Service information

Water is leaking out of the appliance FC7070

Reference no.: SDA_99172

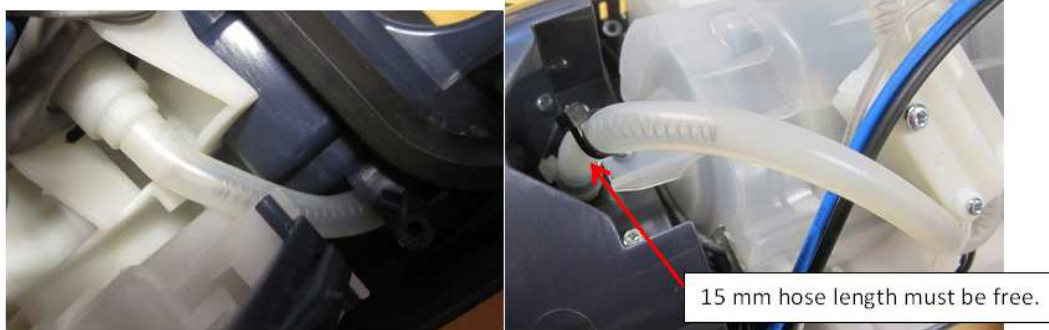
To avoid this problem, 2 components can be added to the appliance during repair :

Spring 432200000371 (pos. 55 in Serv. Manual and Service BOM)
Tiewrap 432200175211 (pos. 56 in Serv. Manual and Service BOM)

Goal is to avoid kinking of the water hoses which cause the leakage of water.

Add a spring to the water hose from the clean water tank outlet to the water sensor.
The spring can be the same as the present used springs (4322 000 00371).
The spring must be fixed with a Tie wrap (4322 001 75211).
The distance is +/- 15 mm from the end to ensure that there is enough hose length to push the hose on the inlet piece.

Add a hose spring to the hose from the water pump to the water inlet piece to the brush.
Use the same spring (4322 000 00371) as already used.
The spring must be fixed with a Tie wrap (4322 001 75211).
Therefor the used hose should be replaced by the same hose (inner and outer) diameter as used for water distribution in the lower stick.
Length must be the same as present pump outlet hose.
